PUBLIC NOTICE

**PROPOSED PERMIT MODIFICATION FOR THE CAMINADA HEADLANDS
BACK BARRIER MARSH CREATION PROJECT BA-171 AND BA-193 IN
LAFOURCHE PARISH**

**CAMINADA HEADLAND BACK
BARRIER MARSH CREATION PROJECT**
BA-0171
LAFOURCHE AND JEFFERSON PARISH, LOUISIANA

PERMIT MODIFICATION

DEWATERING AREA
 TYPICAL SECTION AND
 GEOTEXTILE DETAILS

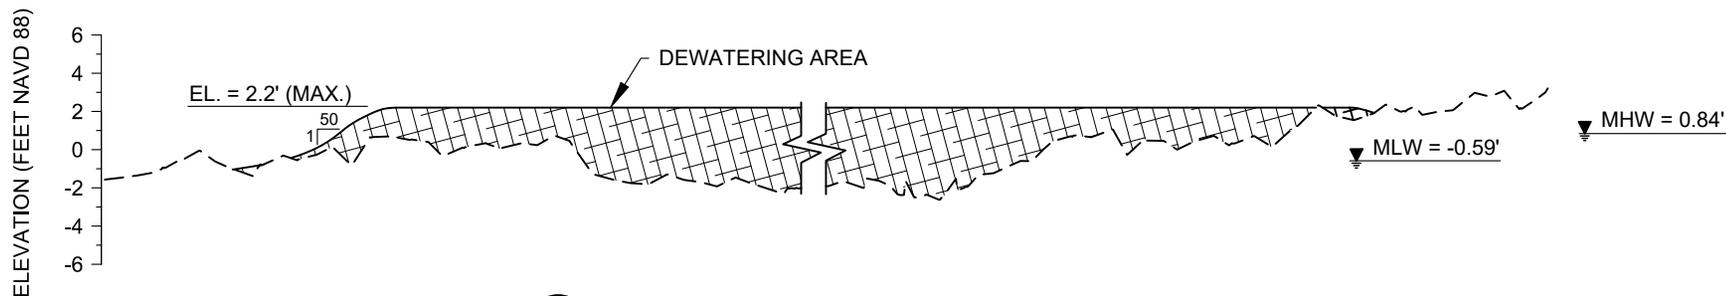
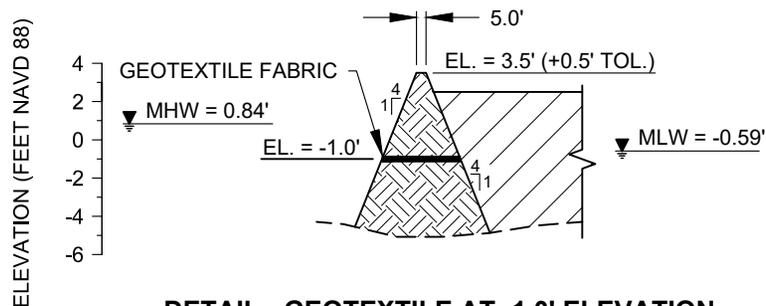
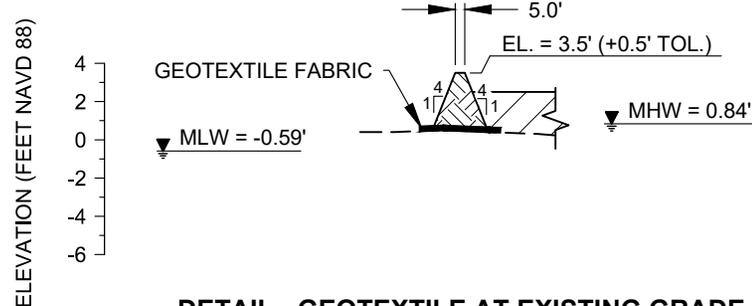
1. REVISED EARTHEN CONTAINMENT DIKE CROWN ELEVATION TO 3.5'.
2. REVISED CONSTRUCTION MARSH FILL ELEVATION TO 2.5'.
